CITY OF CORCORAN  
**Corcoran Planning  
 Commission Agenda**  
**September 7, 2023 - 7:00 pm**

<b>Planning Commission Meeting:</b> September 7, 2023	<b>Prepared By:</b> Kendra Lindahl, AICP
<b>Topic:</b> Red Barn Pet Retreat Comprehensive Plan Amendment, Rezoning, Preliminary Plat, Conditional Use Permit and Site Plan (PID 01-119-23-44-0045) (City File No. 23-008)	<b>Action Required:</b> Recommendation

Figure 6 - Preliminary Plat of Red Barn Pet Retreat

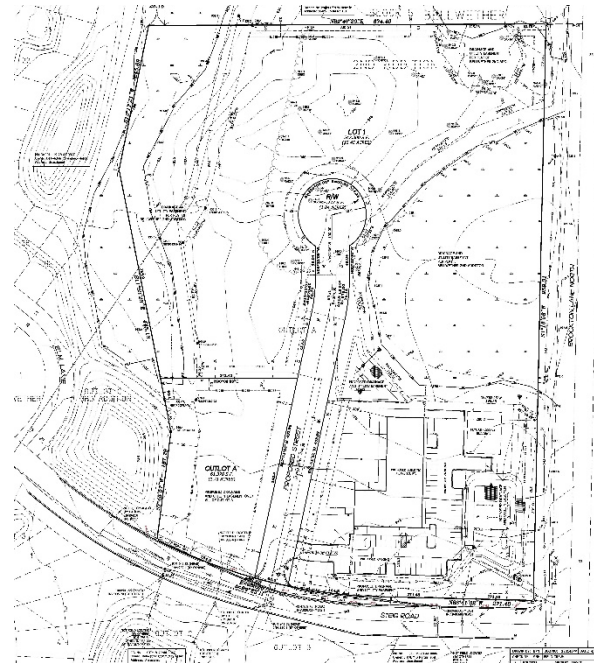
A public street with a 60-foot right-of-way and cul-de-sac will be dedicated to the City as part of this plat. However, the applicant requests that he not be required to build the public street at this time as it will be unnecessary for the current phase of development which is limited to Lot 1. The street would be built out at the time of additional phases of development. For the interim, the applicant will construct a driveway in the public right-of-way to serve Lot 1.

This will require an encroachment agreement with the City. This is similar to what the City permitted for Nelson Trucking to the north, which has private drive in a public right-of-way until the public street is built with future development.

Figure 7 - Site plan

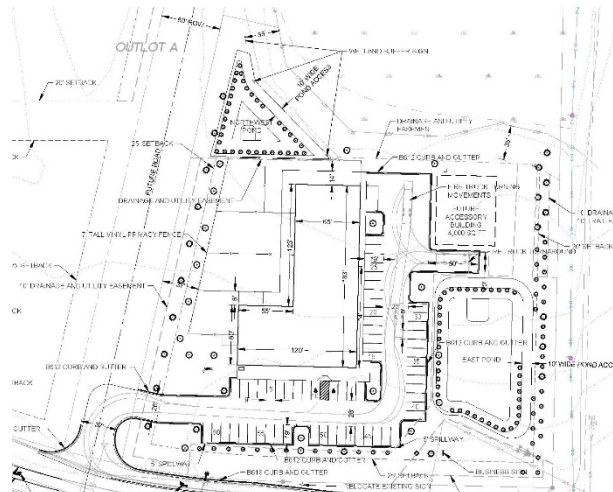
The SWPPP plan shows post-construction impervious surface area of 1.64 acres, which would be well below the 80% impervious surface coverage limit for the district. However, the synthetic turf for the play area may be considered impervious, and it is unclear whether this area was considered in the impervious surface calculations. The applicant will need to work with engineering to confirm how the proposed turf is handled for impervious surface calculations and provide an updated calculation if needed.

The current plans do not provide stormwater management for the future street and future development, but additional stormwater ponding will be required and will result in the loss of future development areas.

Figure 10 - Landscape Plan

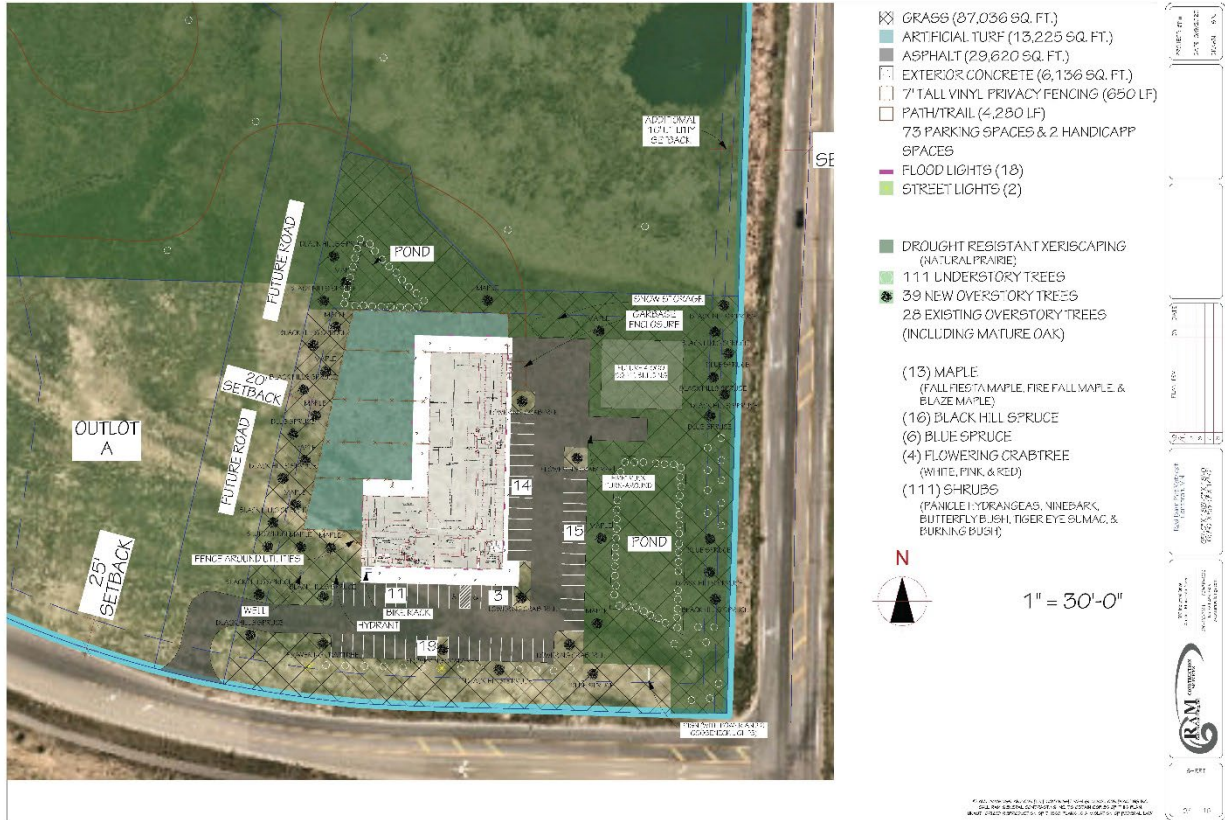
The applicant's landscape plan shows 35 overstory trees, 6 understory trees and 111 shrubs. Three understory trees can be substituted for overstory trees bringing the total to 37 overstory trees. The plans also notes that the plan will preserve 28 mature trees, but those trees are not shown on the plans.

Staff believes that since the large lot is planned for future subdivision, it would be reasonable to allow less than the 82 trees and 137 shrubs required on site based on the larger site perimeter calculation. As noted previously, the plans must be updated to provide shrubs along south and east side of the parking lot to screen headlines. This will likely require at least 111 shrubs and possibly more. Staff supports the 37 overstory trees and a minimum of 111 shrubs for this site if all other screening requirements are met.

1 SOUTH ELEVATION  
 A4 SCALE: 1/8" = 1'-0"  
 1,176 SQ. FT. (55%) RED LP SMART SIDING, 213 SQ. FT. (10%) STONE VENEER, & 743 SQ. FT. (35%) GREY LP SMART SIDING

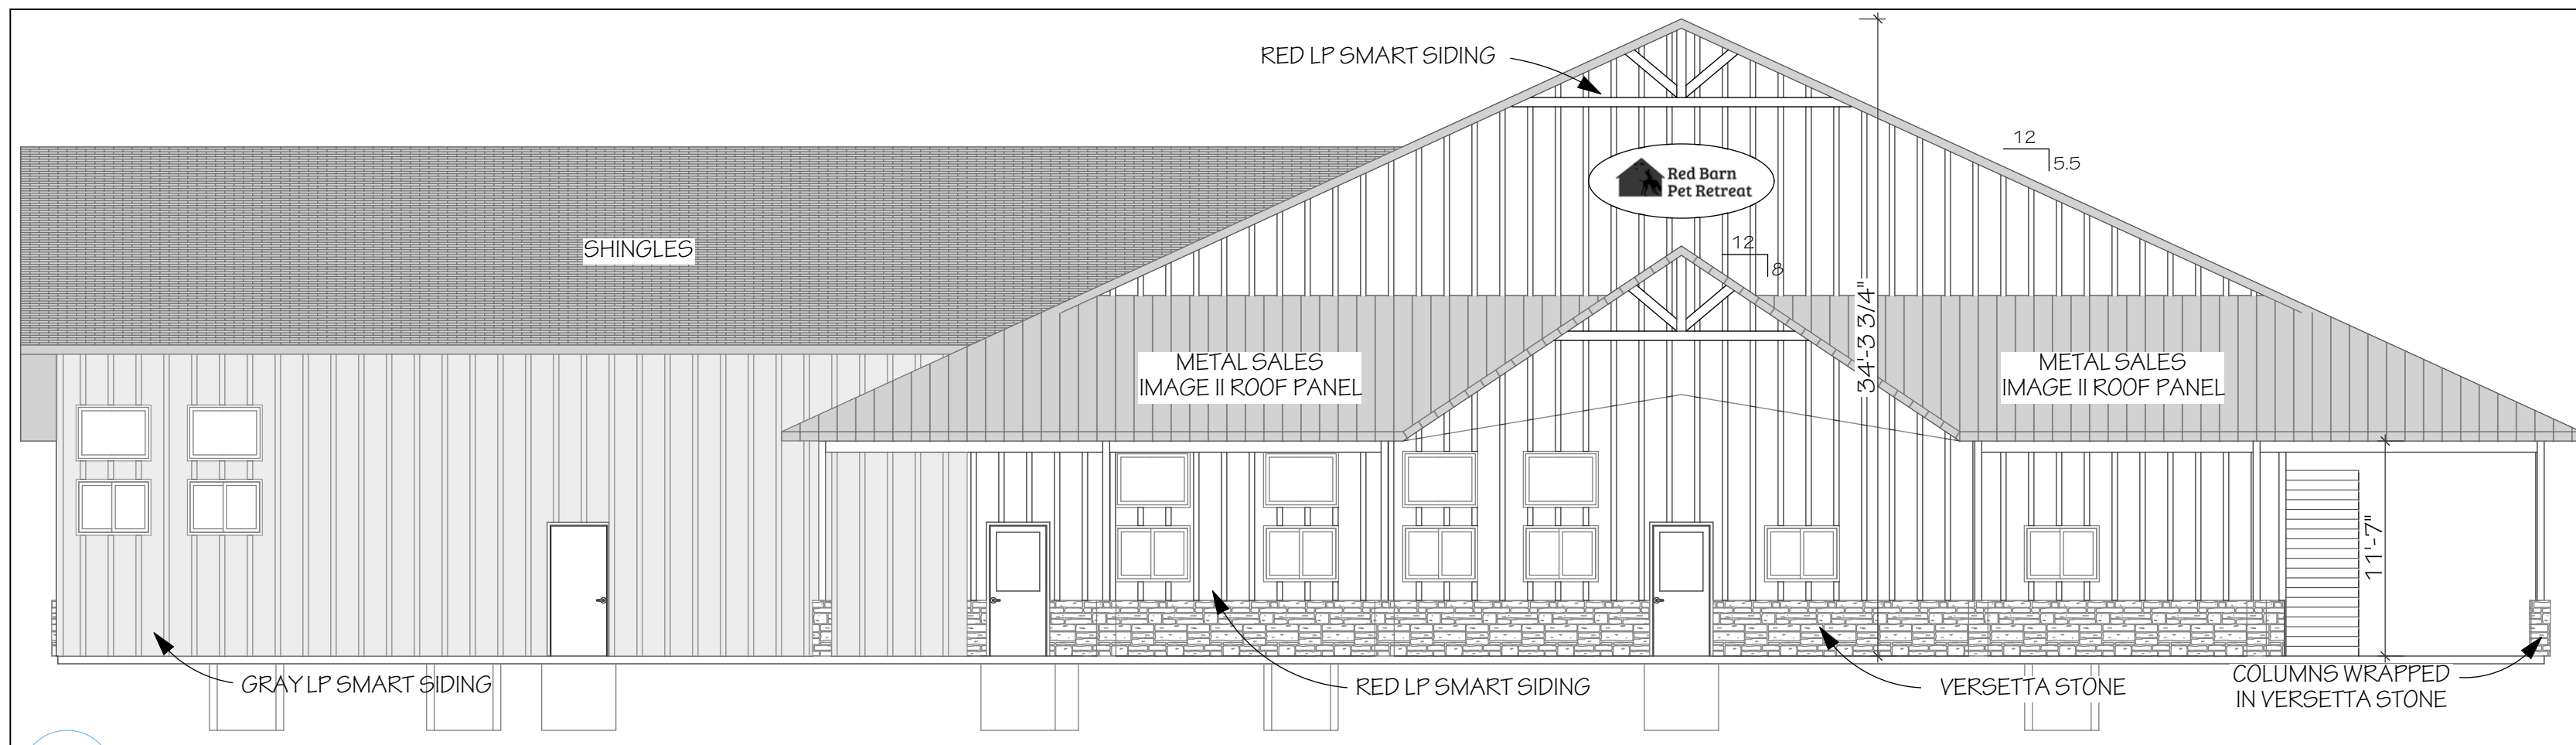
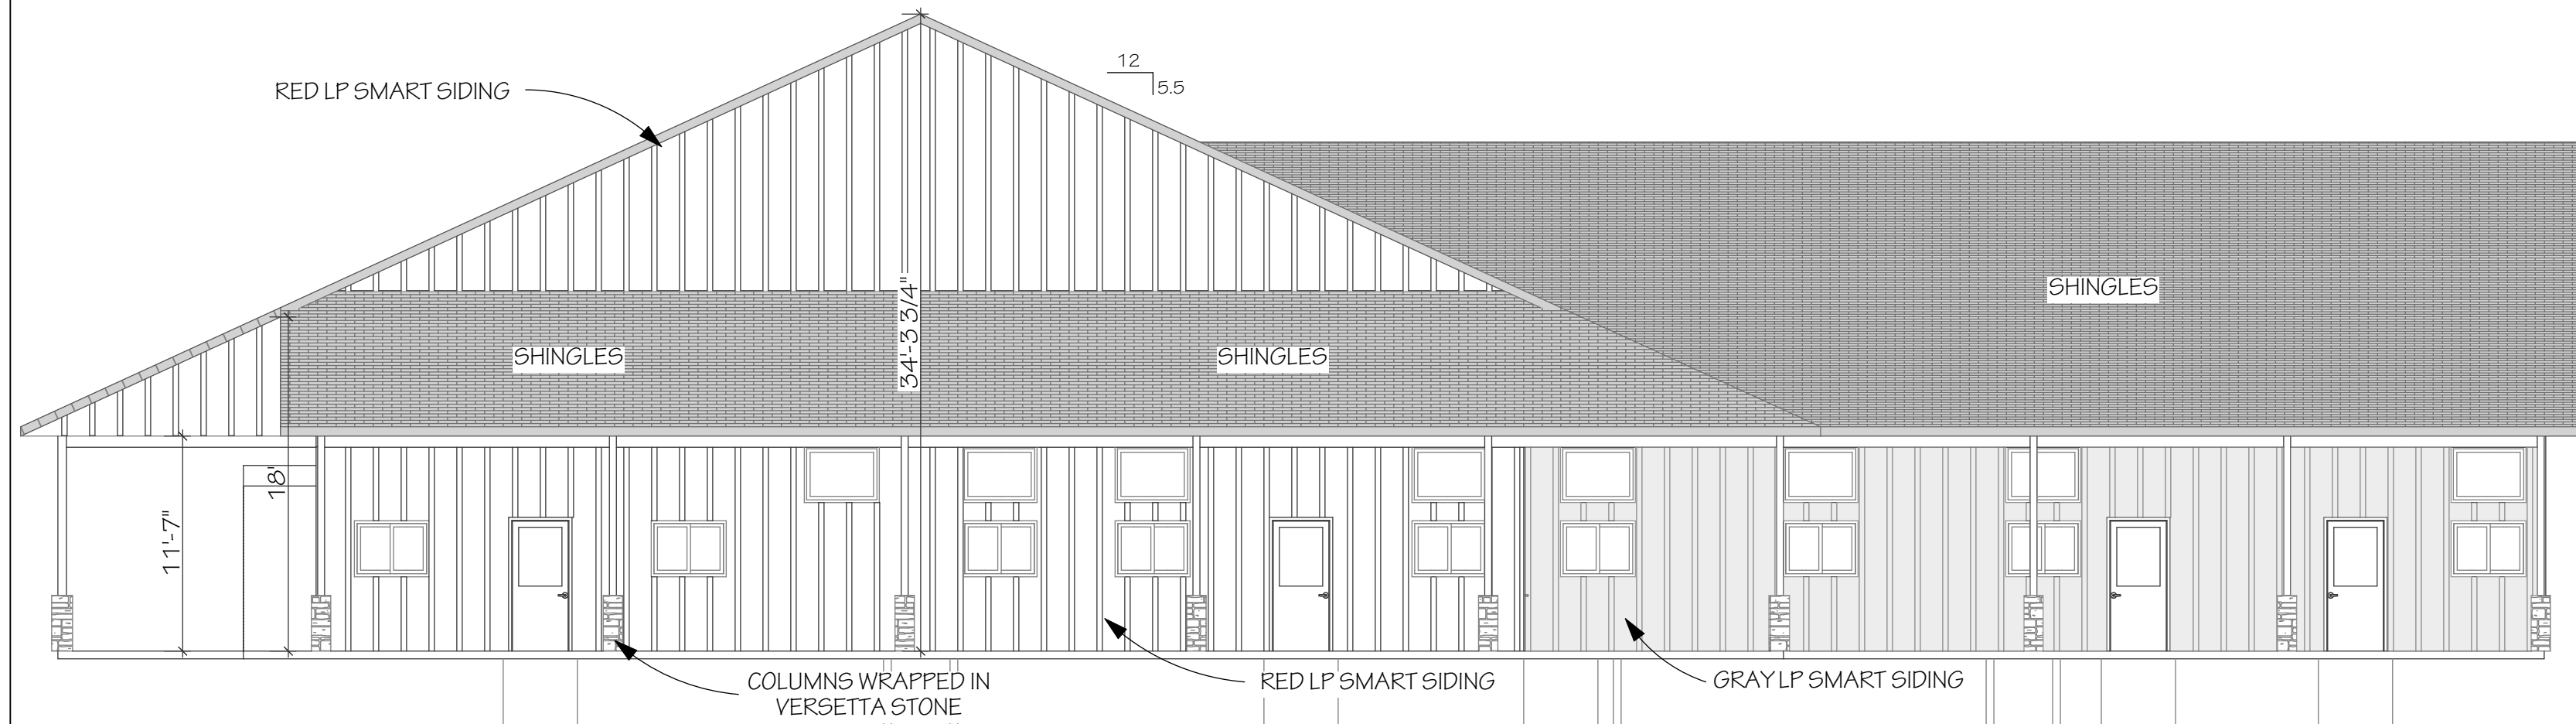
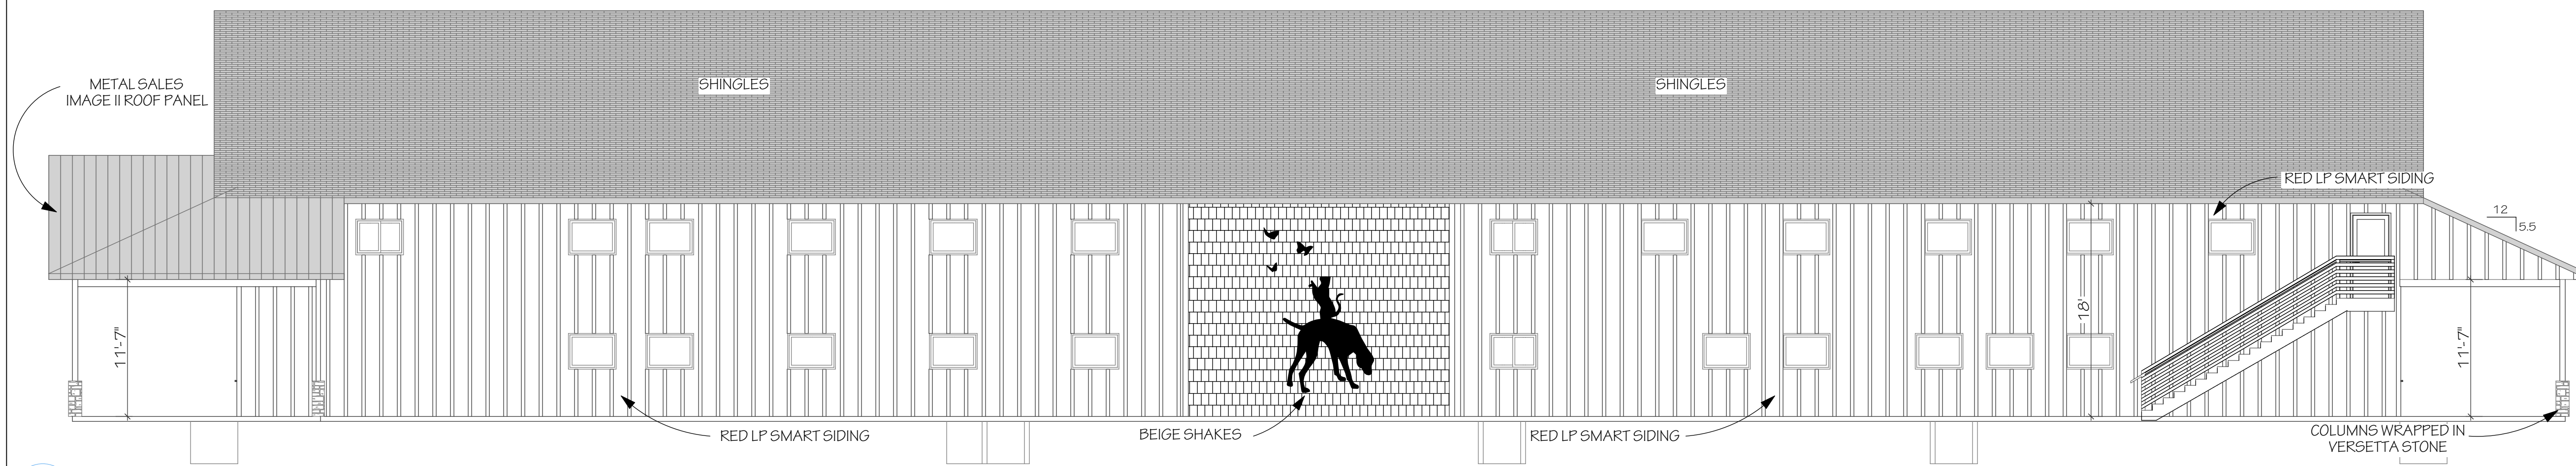
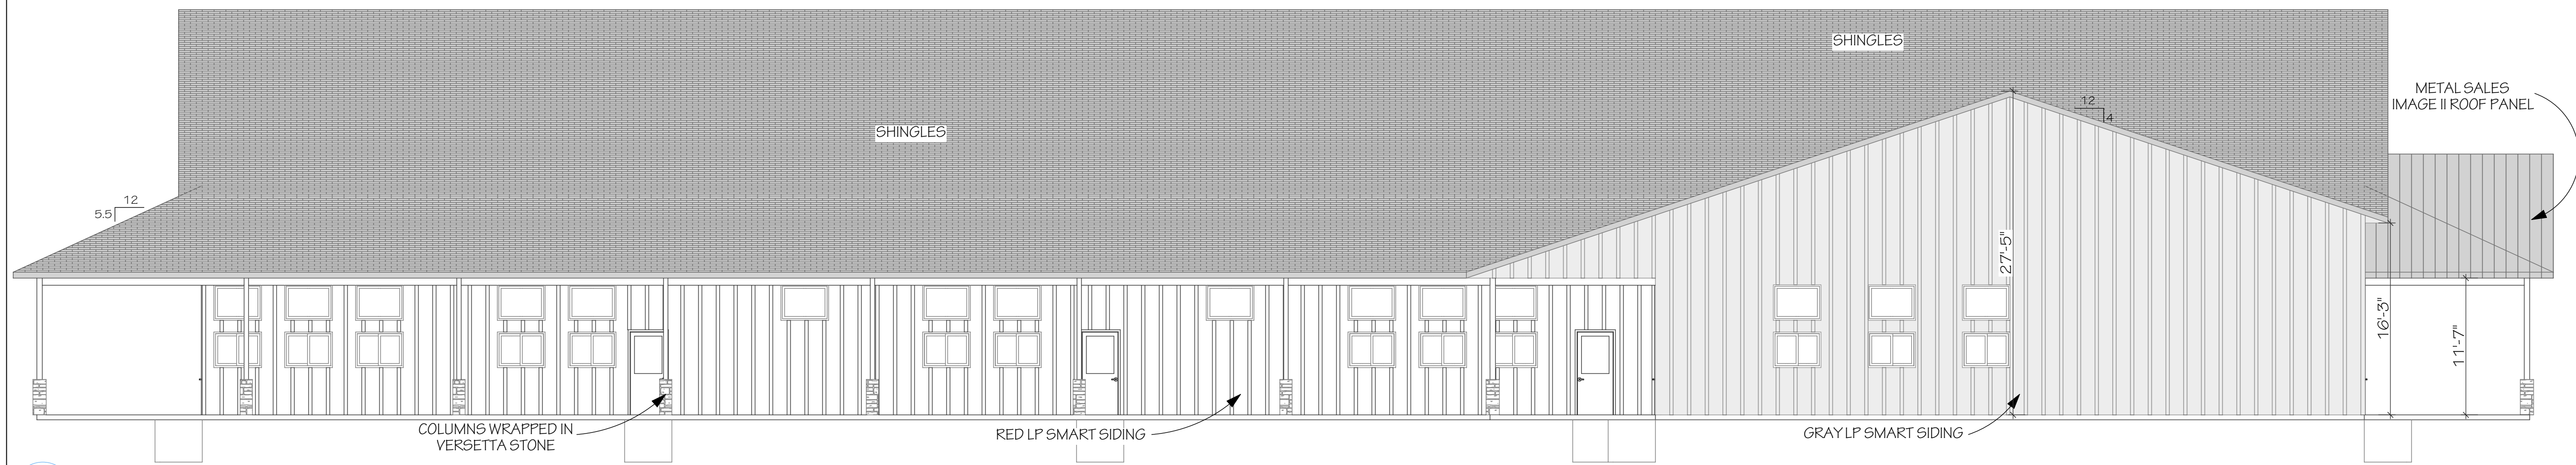
The plans state that the east elevation includes a combination of red and grey LP Smart Siding and versetta stone wrapping the columns. The plans also show beige shakes with a mural. The applicant indicates that these shakes are LP Smart Siding. Assuming the Council approves the use of LP Smart Siding (and shakes) for this site, then the building materials comply with the NE District standards with a condition of approval added in the draft resolution that the stone veneer comply with the thickness standard of at least 5/8 inches.

### Comments from 12/7/2022:

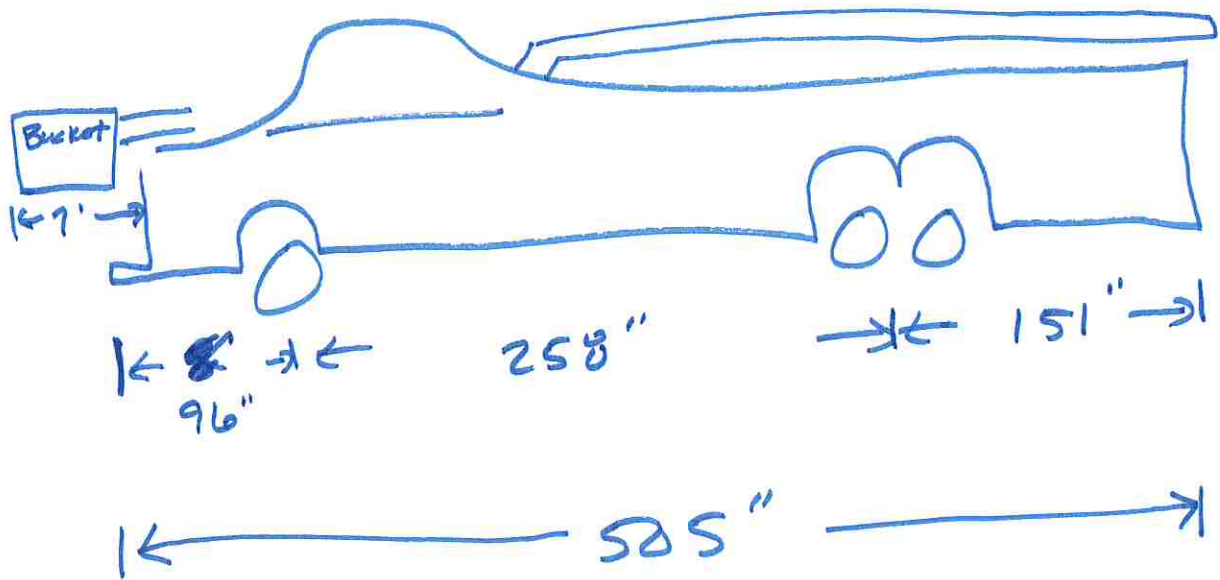
1. On-site hydrants will be required.
2. The applicant will need to confirm with the building official if the building needs to be sprinklered for the Red Barn Pet Retreat needs to be sprinklered as plans are finalized.
3. Two-access onto Stieg Road will not work in this area due to the large traffic volume on Stieg Road and it is too close to the turn lanes. Accesses should be turned internal to the site.
4. A turn-around may be needed for the parking area shown on the east of the Red Barn Pet Retreat if that portion of the site is over 150 feet.
